MISSISSIPPI DEPARTMENT OF TRANSPORTATION

Inter-Departmental Memorandum

SUBJECT OR PROJECT NO: Pipe Policy

FACT SHEET

PLAN-PROFILE
ROADWAY DESIGN DIVISION C.A.D.D. SECTION
MISSISSIPPI DEPARTMENT OF TRANSPORTATION

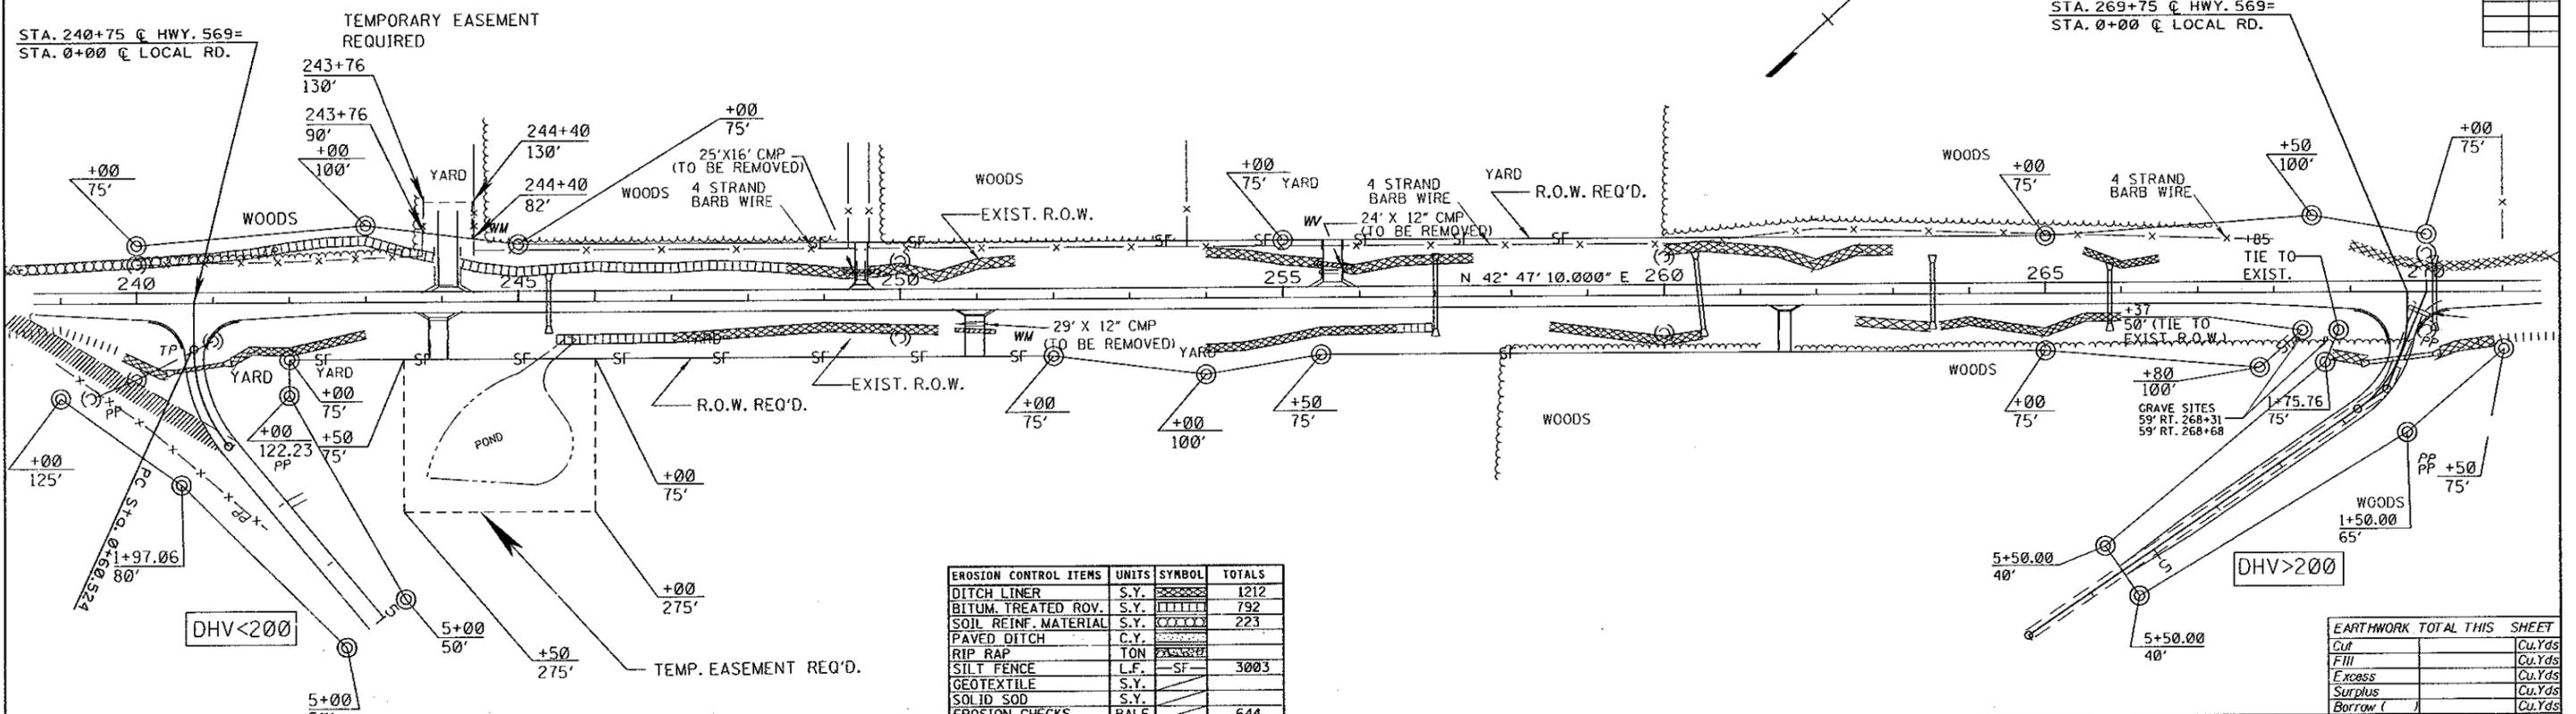
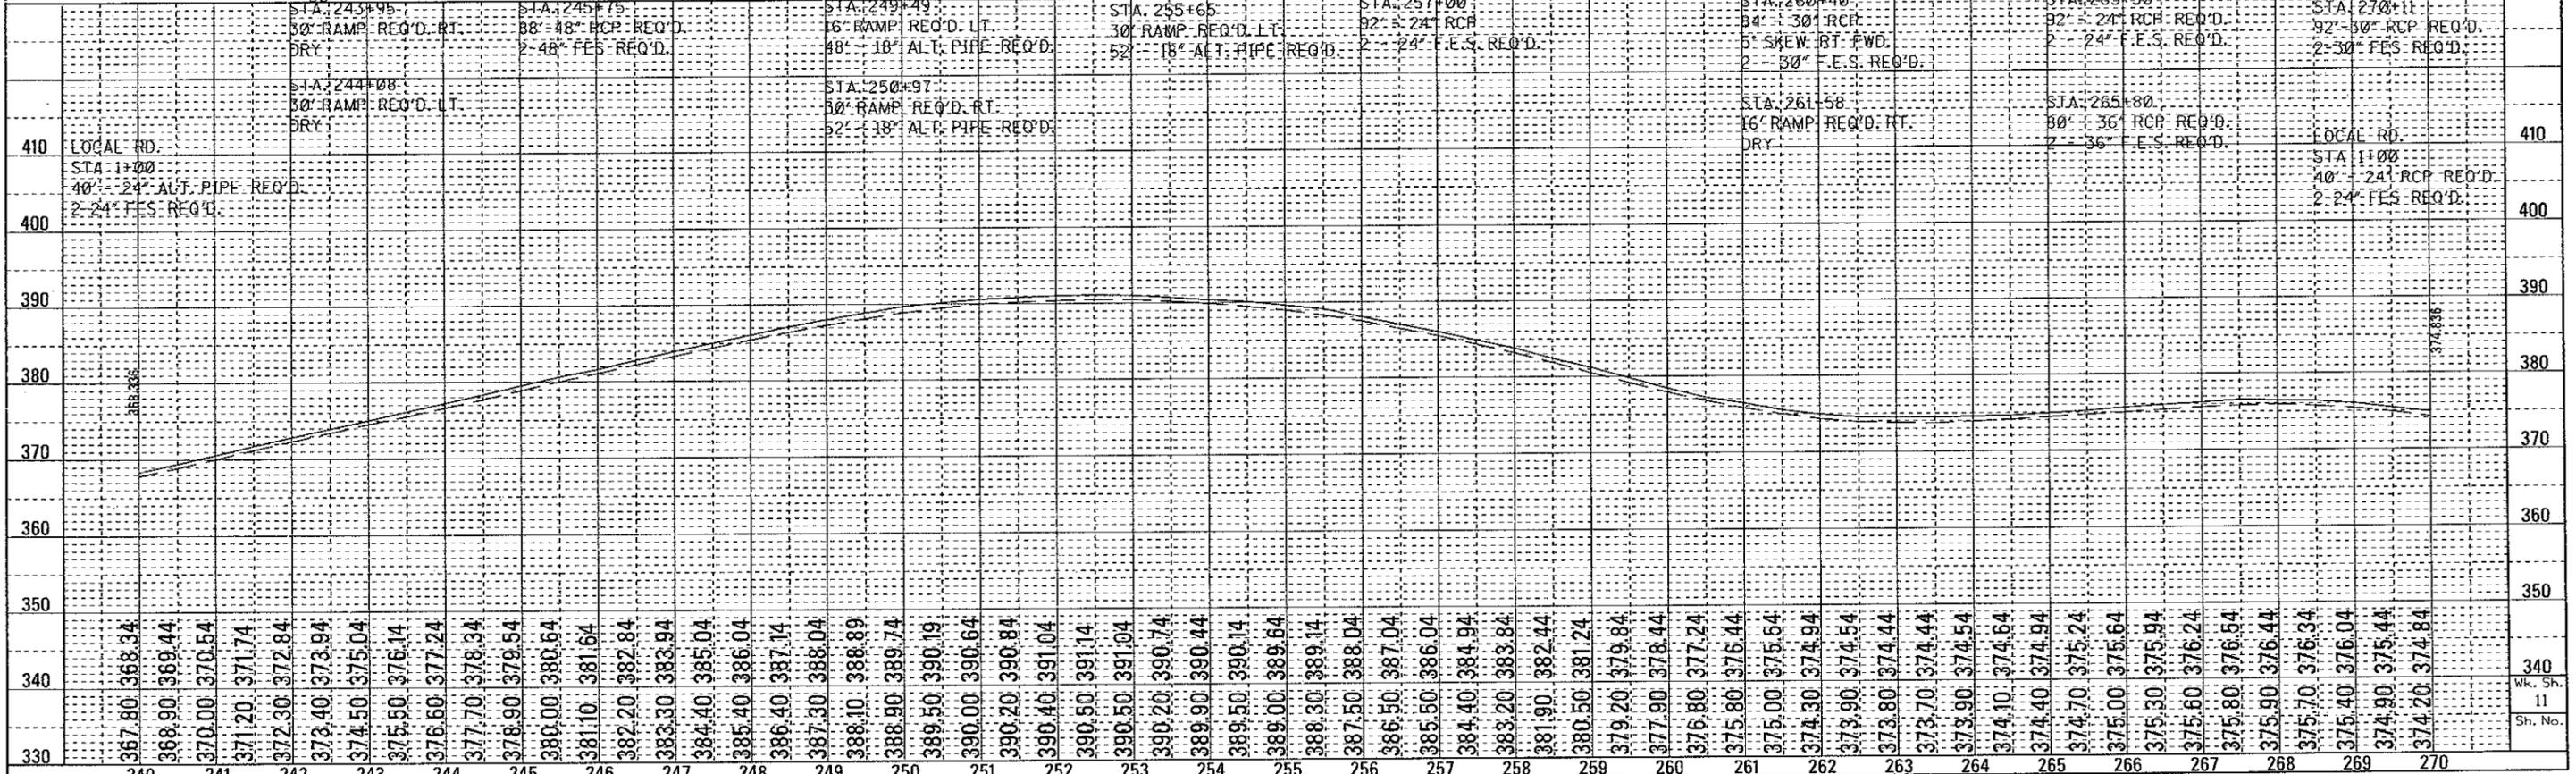
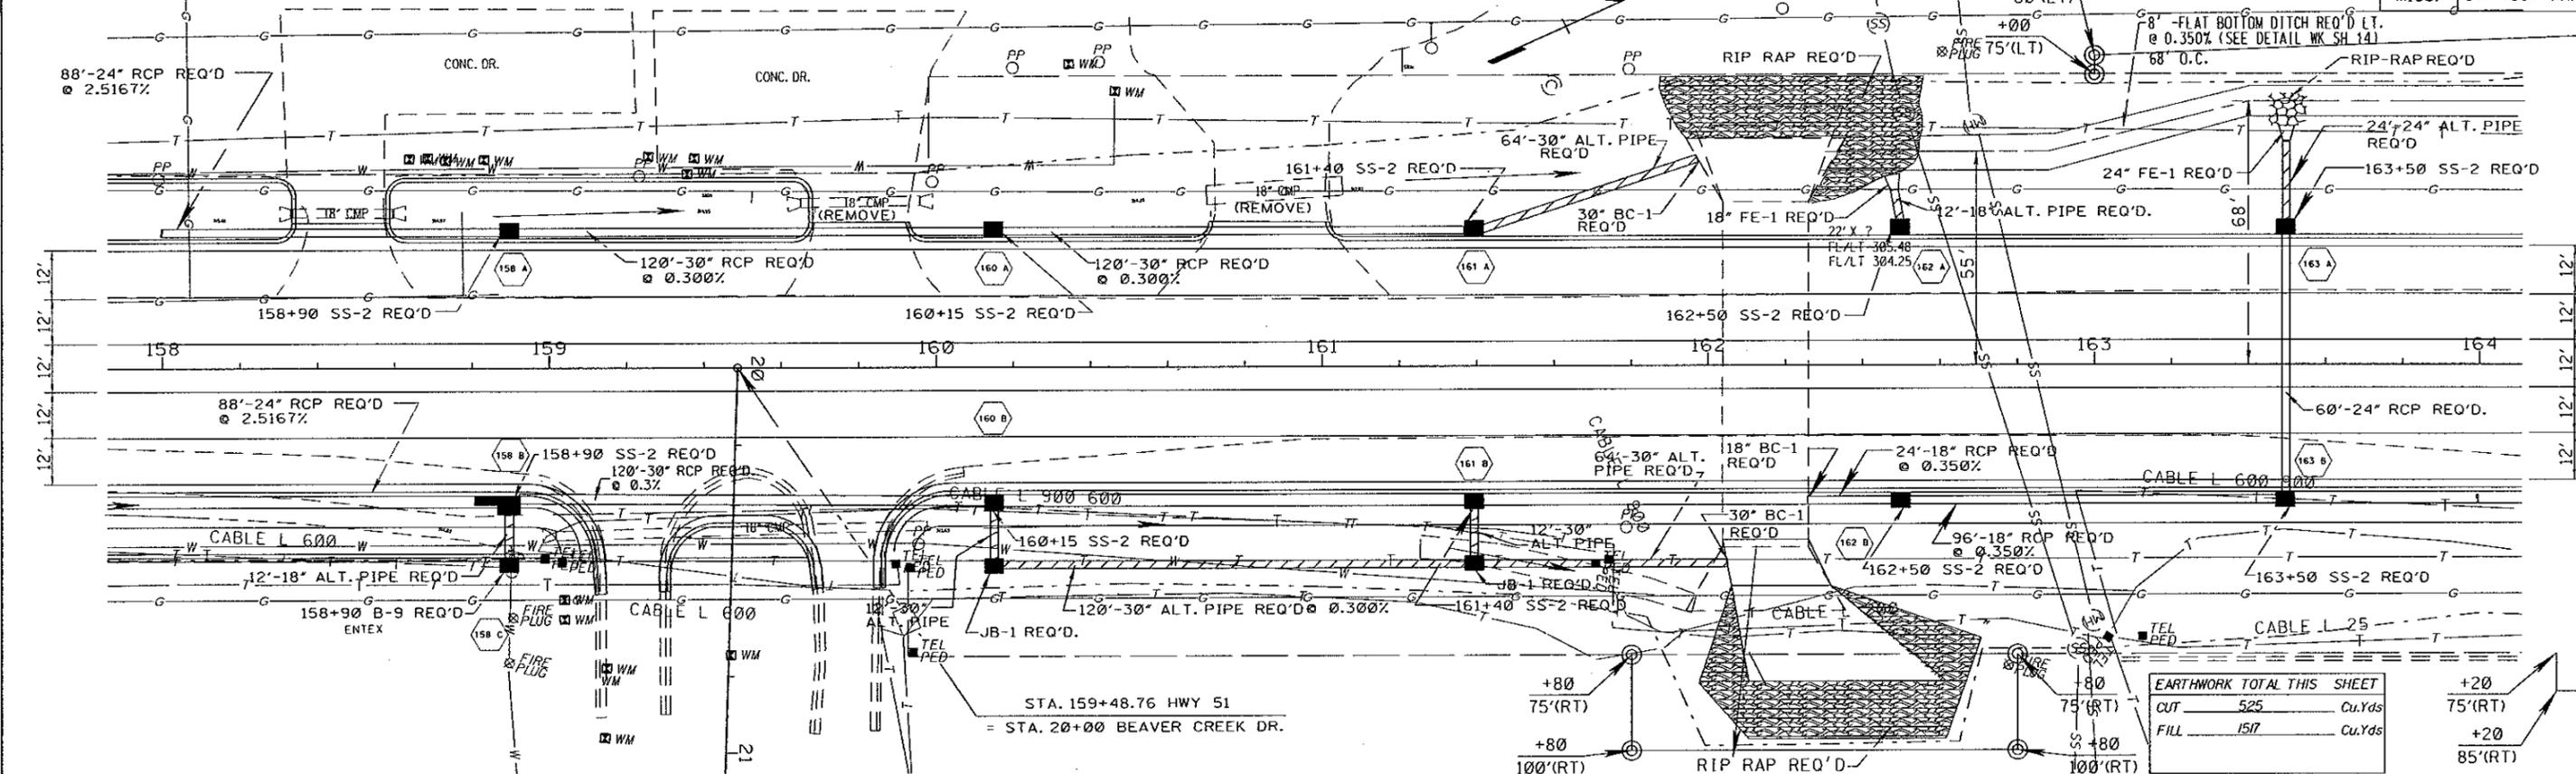
8. Pipe locations will be shown on the plan/profiles as they have been shown in the past. The difference will be that alternate pipes will be striped to differentiate between alternate pipe locations and concrete pipe locations. See plan/profile example sheets.
